# WOLF CREEK

Reference: 1) Letter CO 95-0010, dated July 29, 1994, from R. N. Johannes, WCNOG, to USNRC  
2) Letter ET 95-0099, dated September 15, 1995, from R. C. Hagan, WCNOG, to USNRC  
Subject: Docket No. 50-482: Response to Request for Additional Information Concerning the Revision to Technical Specification 3/4.8.1, "Electrical Power Systems - A.C. Sources"

**Response to Request for Additional Information**

Figure 2  
Typical Full-Load Rejection Test  
(Page 1 of 1)

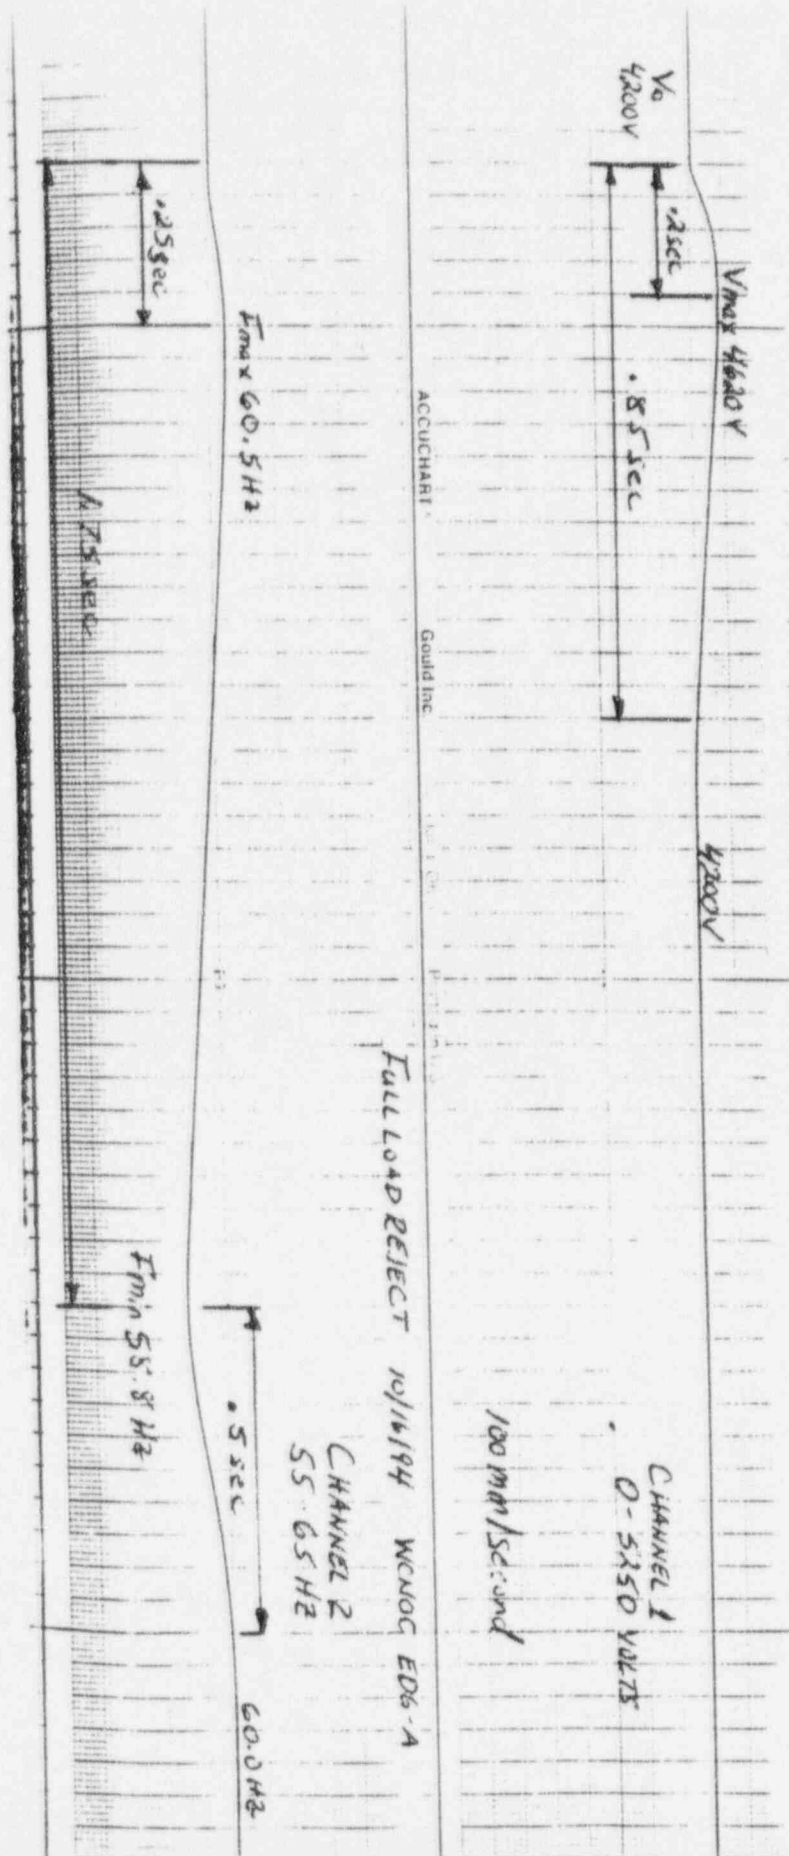
- A. The single-load rejection test is enveloped by the full load rejection test since the proposed change revises the frequency criteria to  $60 \pm 5.4$  Hertz which is the current frequency for the single largest load rejection test. Figure 1 provides a strip chart recording for the Callaway Plant for a typical full-load rejection test. Figure 2 provides a recording for Wolf Creek Generating Station (WCGS) of a typical full-load rejection test.

Figure 3  
Blackout Load Sequencing the ESW Pump Load Rejection  
Tests  
(Page 7 of 8)

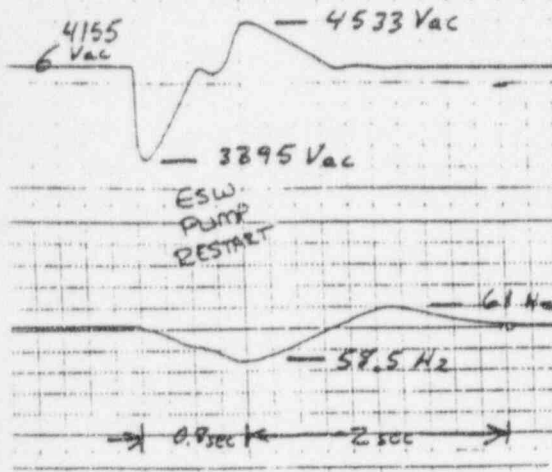
duration of the transient to steady state was 1.7 seconds for the voltage transient and 3.0 seconds for the frequency transient. The ESW pump rejection shown on page 7 of Figure 3 indicates no minimum voltage transient and a rise from the steady state voltage of 4155 Vac to a maximum of 4234 Vac with a duration of 0.2 seconds. The frequency transient shows no minimum frequency transient and a rise from the steady state frequency of 60.2 Hertz to a maximum of 60.6 Hertz with a duration of 1.1 seconds. Figure 4 provides a recording of voltage and frequency during a typical single-load rejection test (pump trip followed by a pump start). During the single-load rejection test, initial voltage was established at 3990 Vac and frequency was 60 Hertz. When the ESW pump was tripped, the maximum transient voltage was 4042 Vac (52 Vac swing) and the maximum frequency was 60.4 Hertz (0.4 Hertz swing). The transient caused by starting the pump was much greater. Voltage ranged from 3307 Vac to 4357 Vac (1050 Vac swing). Frequency ranged from 58.7 to 60.7 (2 Hertz swing). This demonstrates that the single-load rejection test is not significant to demonstrating operability of the diesel generator.
